Memorandum to the City of Markham Committee of Adjustment

File: A/014/24
Address: 3882 Highway 7 East, Markham
Agent: KLM Planning Partners Inc. (Marshall Smith)
Hearing Date: Wednesday, May 1, 2024

Figure 1: Original Proposal

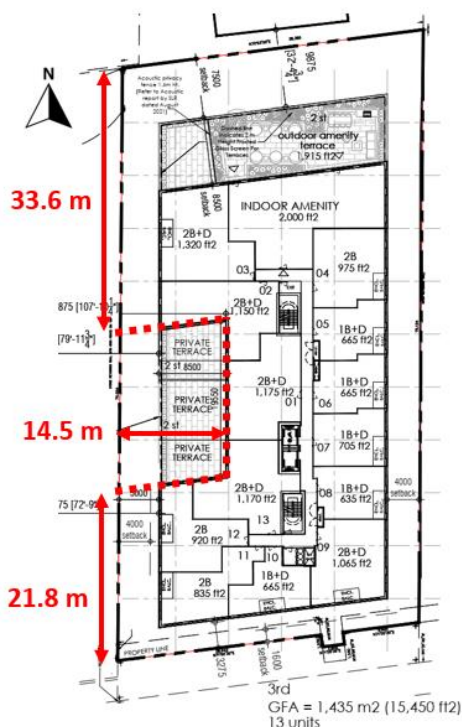
Staff note that the building orientation of the Original Proposal was parallel to the front and rear property lines. As such, the associated By-law provisions for the interior portion of the C-shaped building was based on the angled property line setbacks, as further demonstrated in Figure 1.

The Proposed Development has been revised so that the building orientation is no longer parallel to the property line, resulting in the above-noted variance request. The area highlighted in yellow in Figure 2 is the approximate area of non-compliance.

Staff note that the Proposed Development meets the intent of the Amending Zoning By-law by maintaining the reversed C-shaped layout. Although some changes have been made to the building configuration resulting in the above-noted variance request, the Proposed Development adheres to all other required exterior setbacks (such as rear, front and side yard setbacks), angular plane requirement, and outdoor amenity space requirements. Staff are of the opinion that the Proposed Development remains relatively consistent with the Council endorsed site plan, meets the intent of the Zoning By-law, and is minor in nature. As such, Staff have no concerns with the proposed variance request.
